PARTS & SERVICE NEWS

REF NO.	AA02227
DATE	Mar. 4, 2003

SUBJECT: REPAIR PROCEDURE FOR DAMAGED ENGINE AND TRANSMISSION MOUNT CUSHIONS

PURPOSE: To introduce modification procedures to repair engine and transmission mount cushions when these parts are found to be deformed, broken or cracked

Detail drawings for the mount rubber

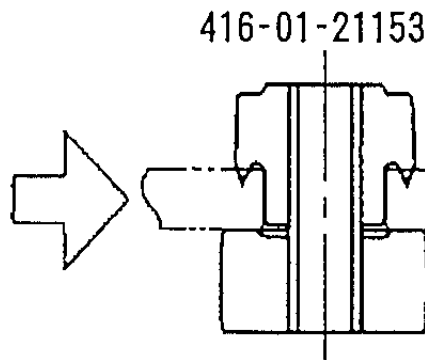
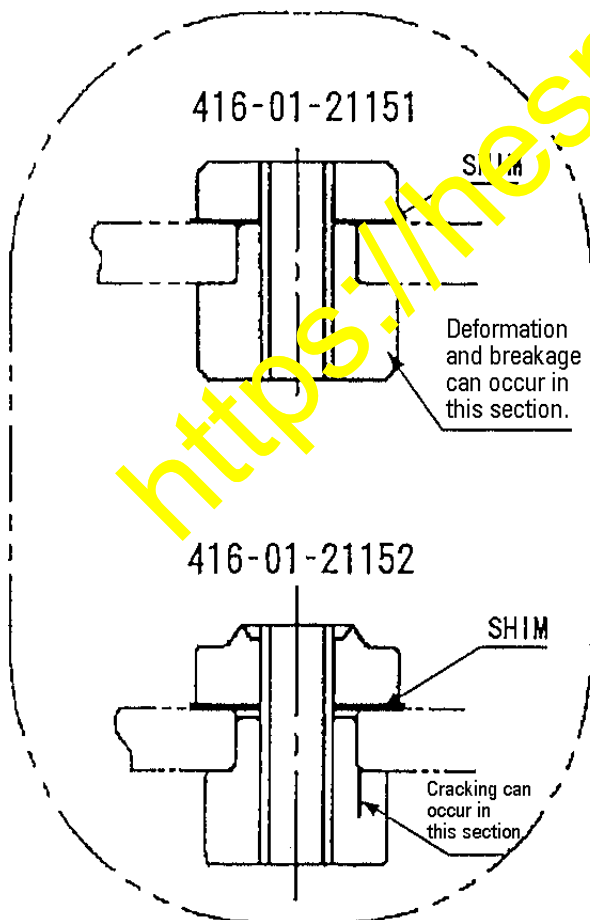
3.1 The shape and the hardness of the mount rubbers have been modified to improve their durability. Also, use of shims has been discontinued pursuant to this modification.

* Pay attention to the direction when installing them.

The shape of the rubber mount has been so modified that the projecting section has been shifted to the upper rubber and the hardness of the material has been changed.

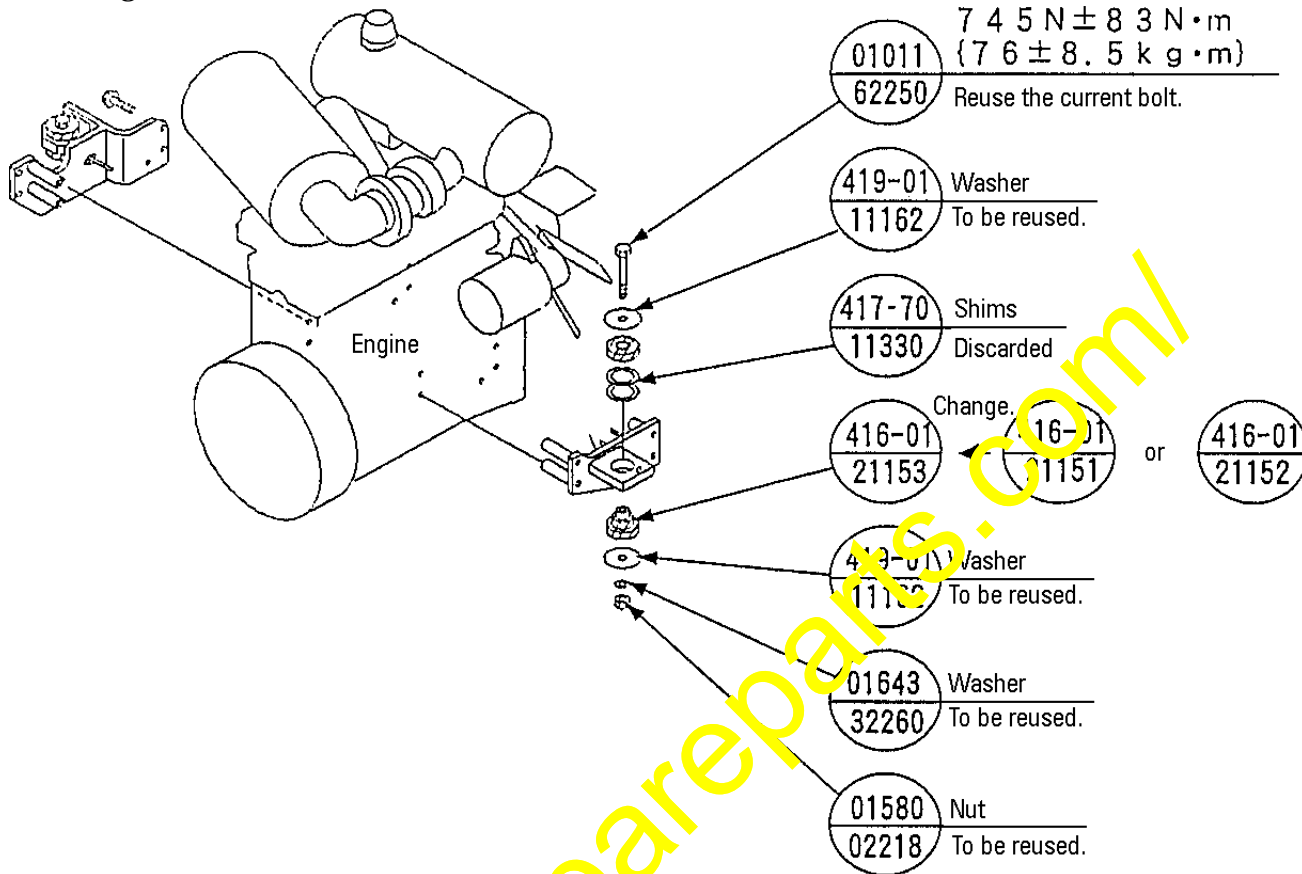
4-1. Replace or discard of the following parts according to respective designations.
